**SAN ANTONIO WATER SYSTEM**  
**WATER PRODUCTION FACILITIES DISINFECTION SYSTEM UPGRADES PROJECT**  
**SAWS Job No. 12-6004**  
**SAWS Solicitation No. B-14-042-DD**

**ADDENDUM NO. 2**  
**August 7, 2014**

SHEET **C-03**  
7 OF 125

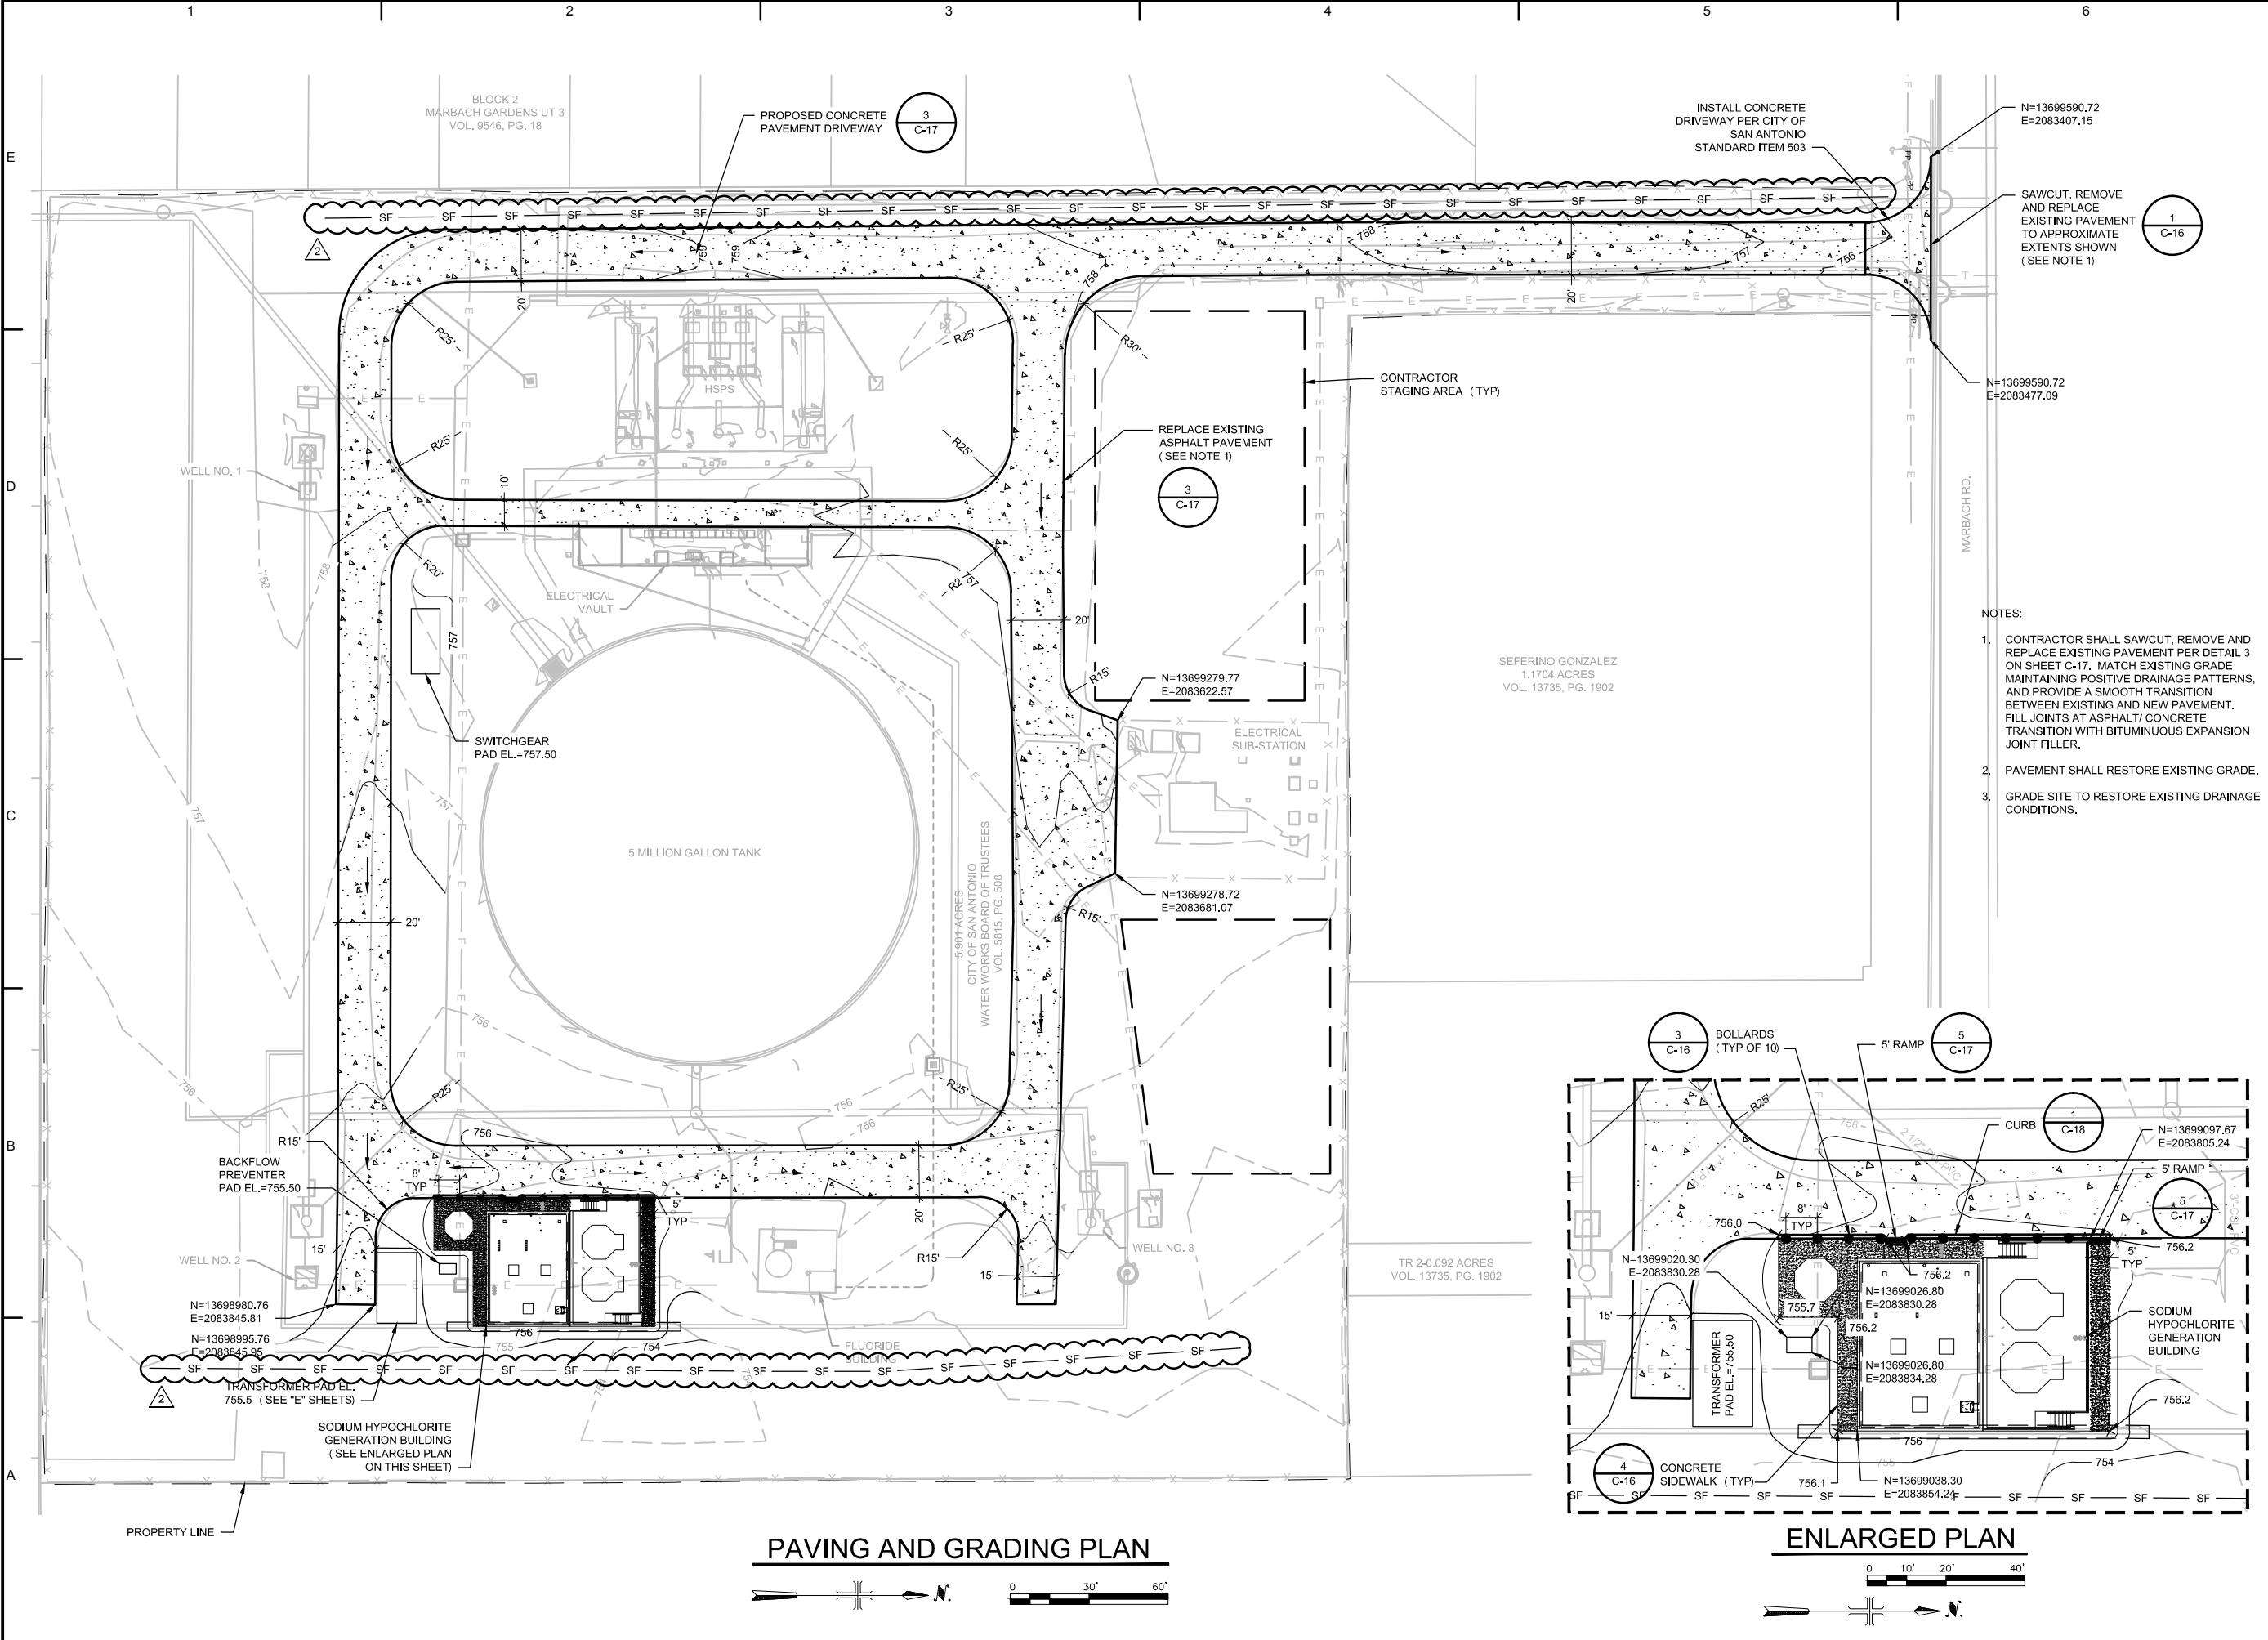
**3. Sheet C-03**

- a. Add fluoride line replacement and 6" PVC Sleeve under access road
- b. Update Note 3
- c. Added silt fence to site plan

SHEET **C-10**  
14 OF 125

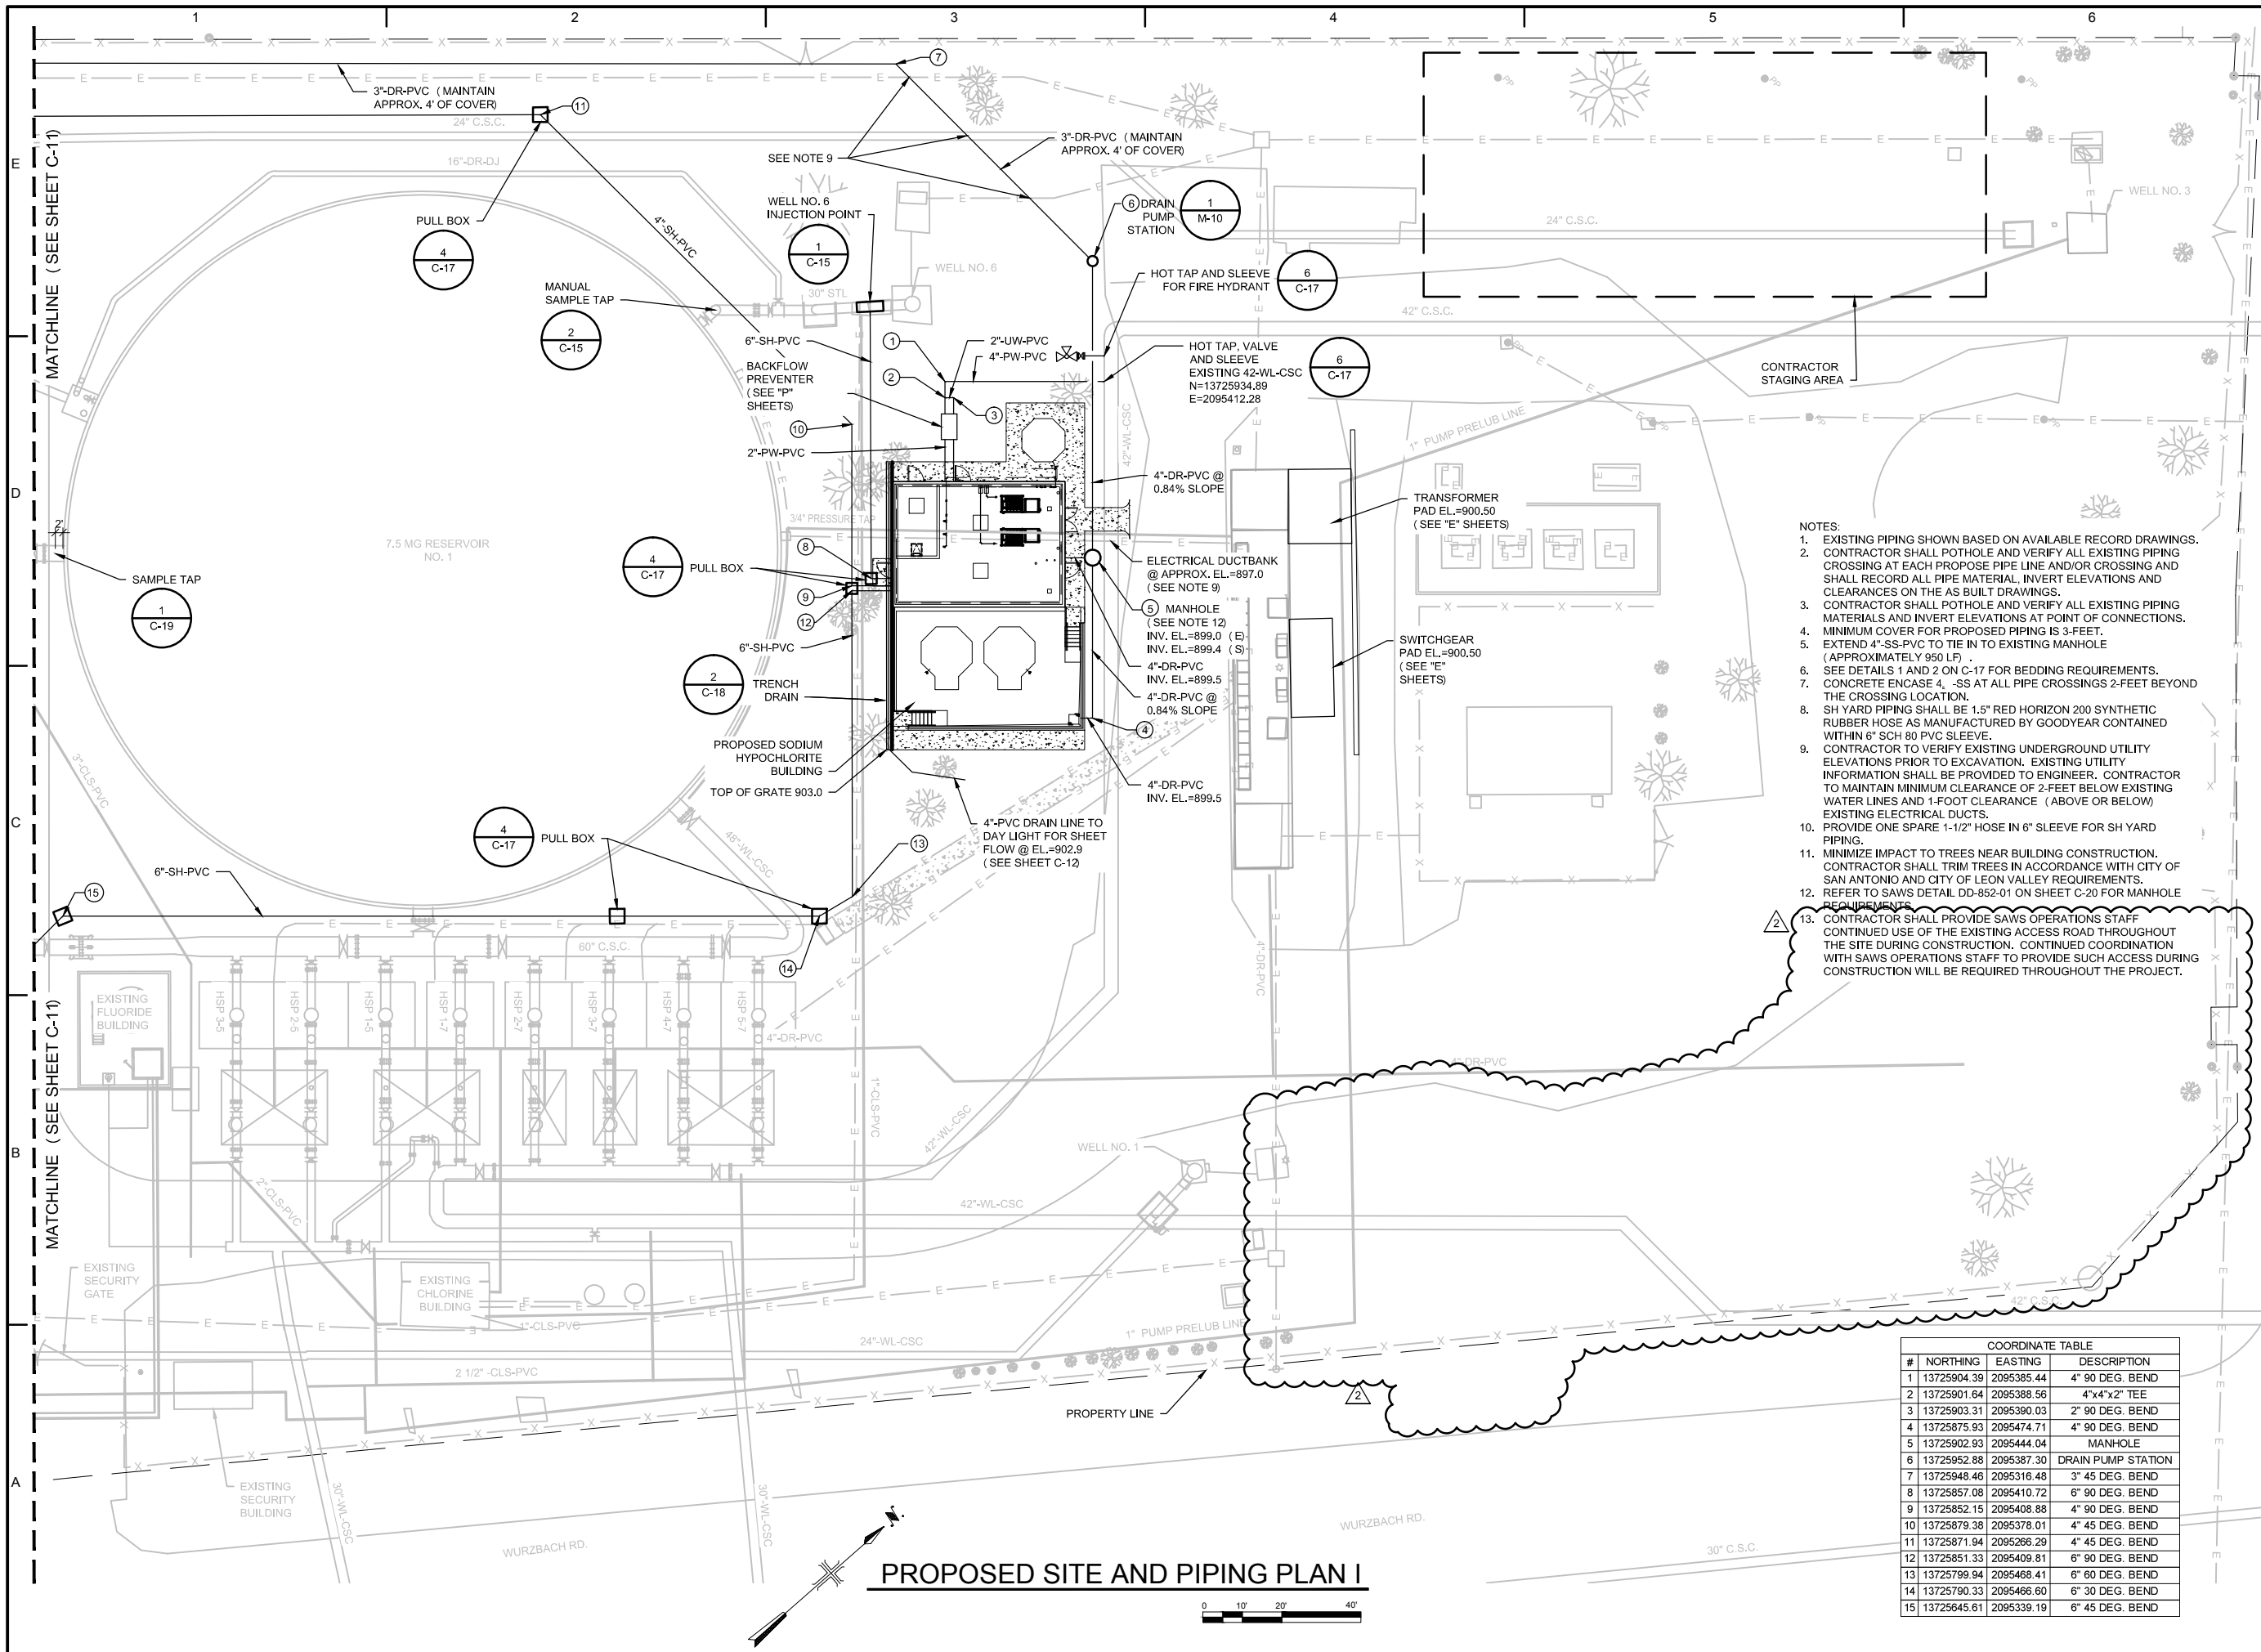
**6. Sheet C-10**

- a. Remove south construction staging area
- b. Add Note 13 requiring that access to existing access roads and entrance/exits be provided to SAWS Operations staff at all times during construction.

- REFER TO SAWS DETAIL DD-852-01 ON SHEET C-20 FOR MANHOLE REQUIREMENTS.
  - CONTRACTOR SHALL PROVIDE SAWS OPERATIONS STAFF CONTINUED USE OF THE EXISTING ACCESS ROAD THROUGHOUT THE SITE DURING CONSTRUCTION. CONTINUED COORDINATION WITH SAWS OPERATIONS STAFF TO PROVIDE SUCH ACCESS DURING CONSTRUCTION WILL BE REQUIRED THROUGHOUT THE PROJECT.

SHEET **C-12**  
 16 OF 125

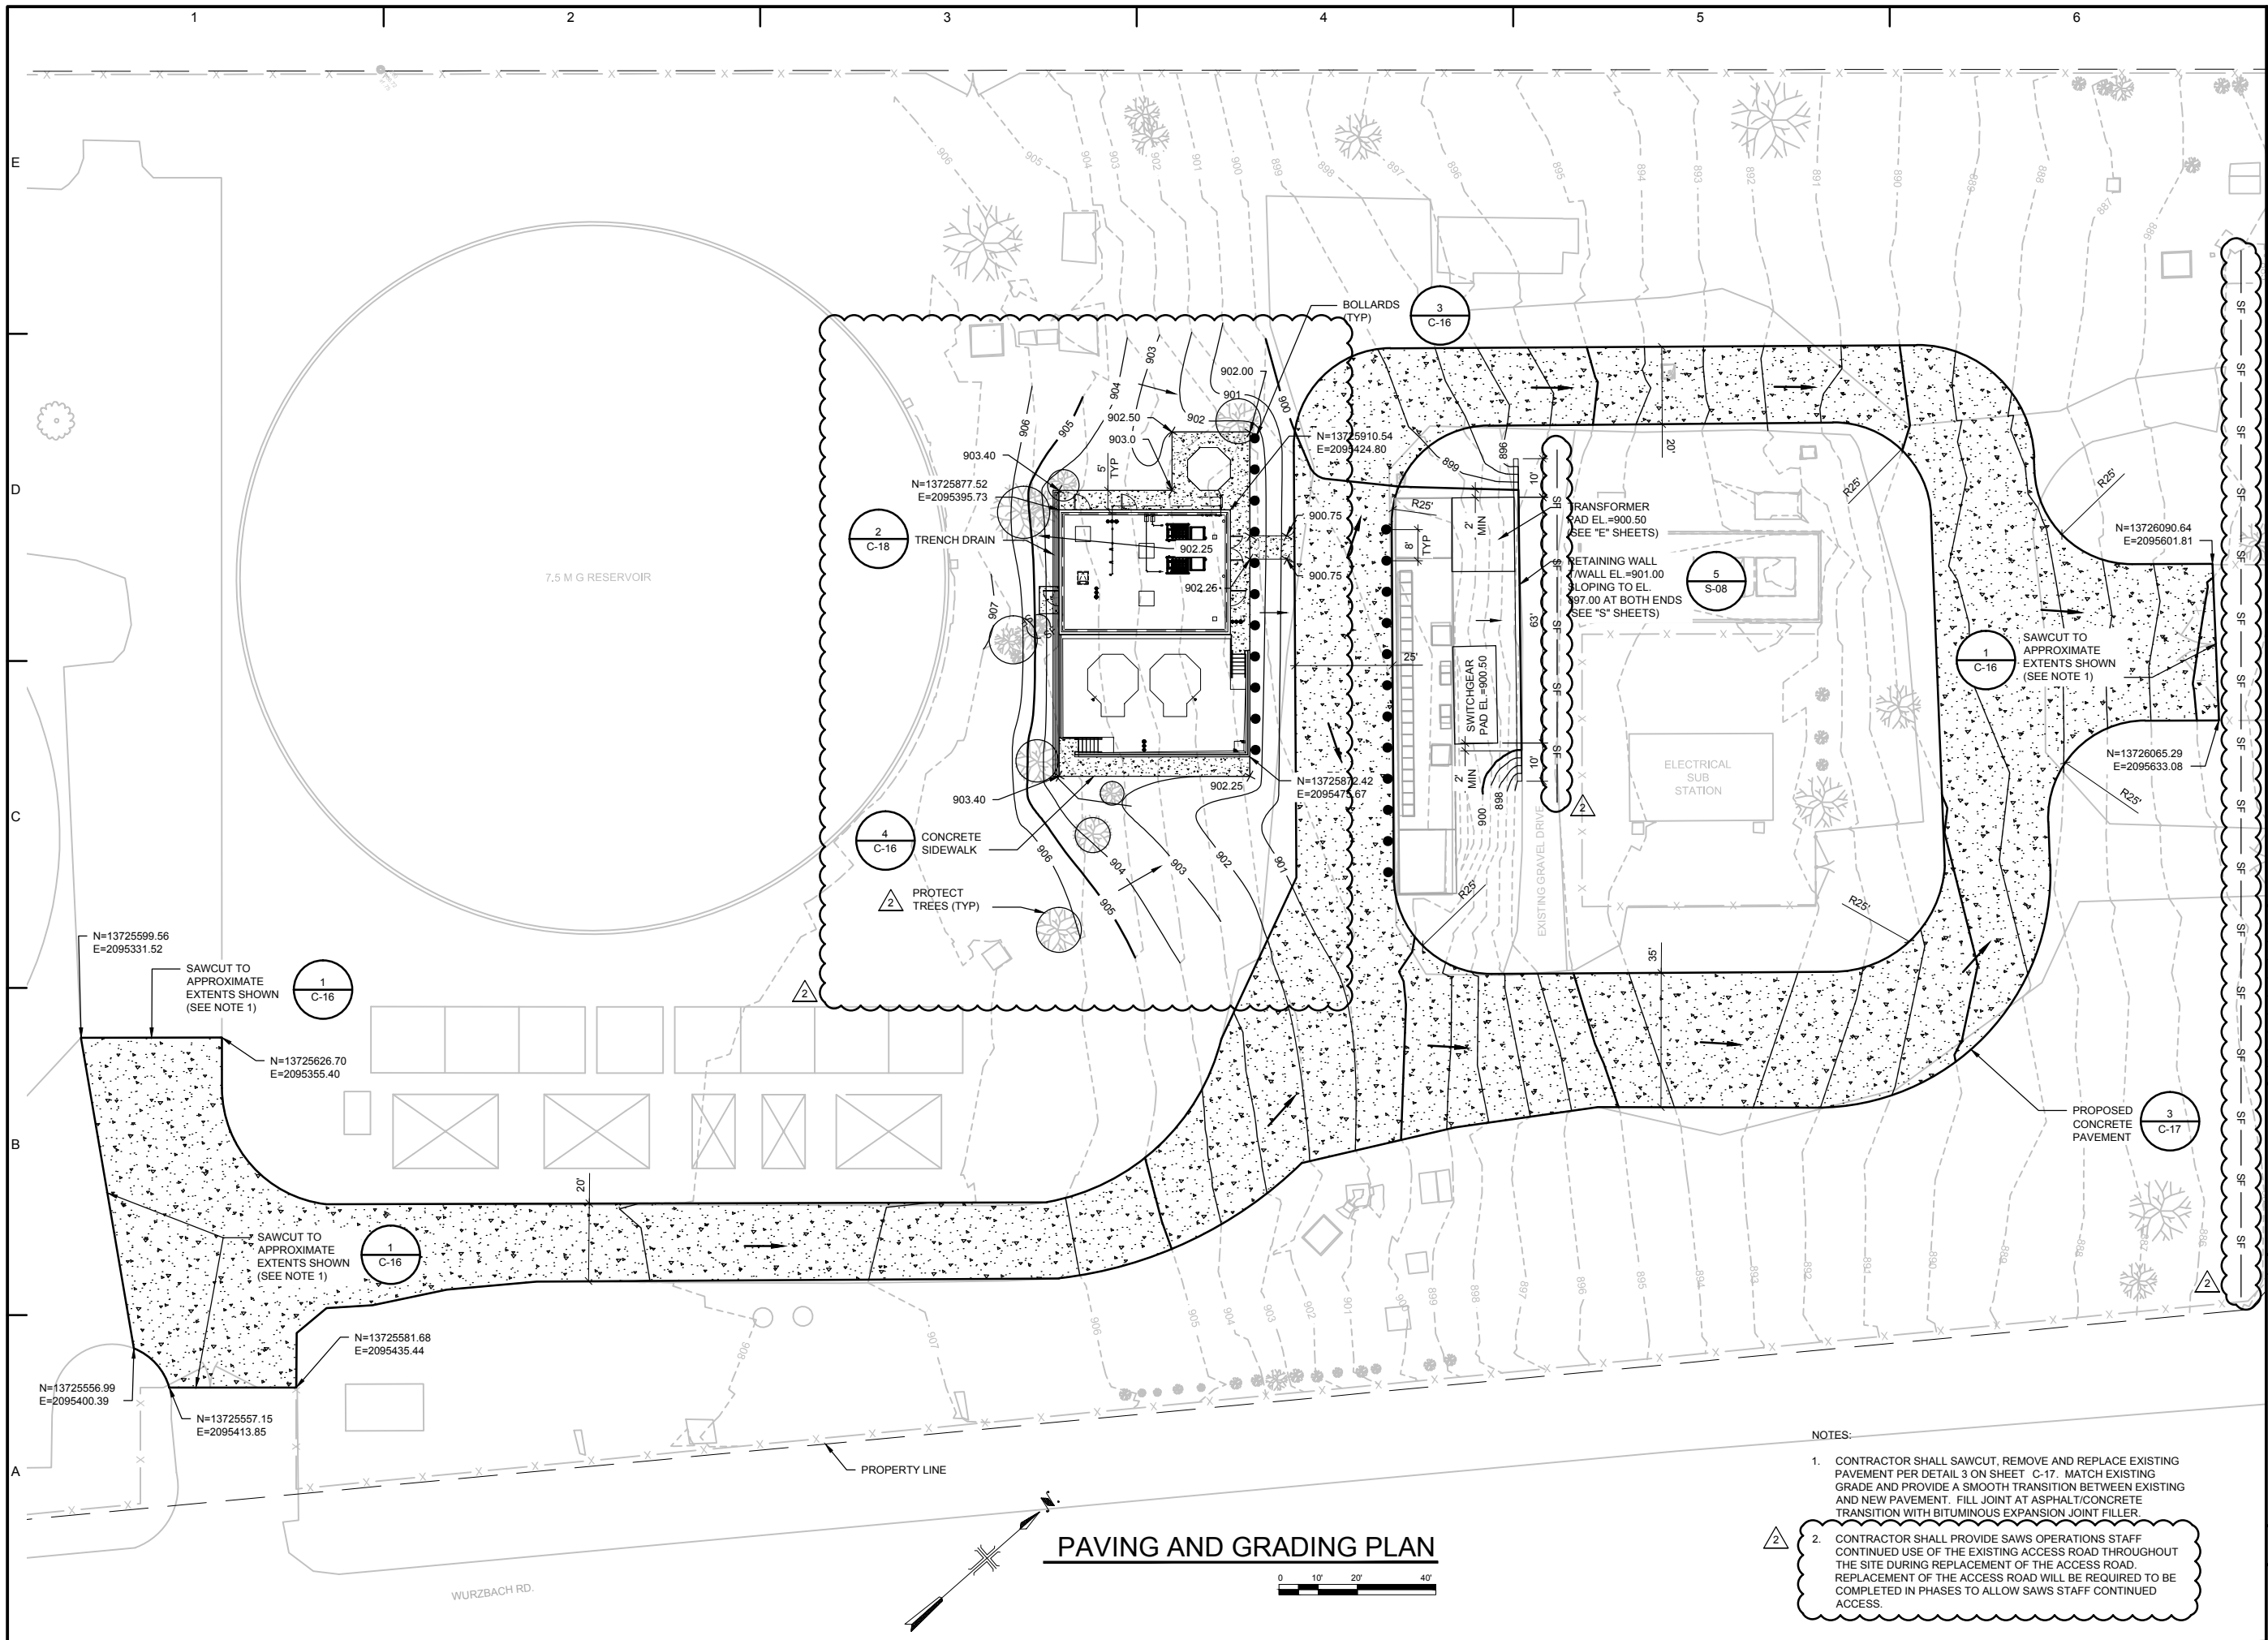
**7. Sheet C-12**

- a. Added silt fence to site plan
- b. Add Note 2 requiring that access to existing access roads and entrance/exits be provided to SAWS Operations staff at all times during construction.
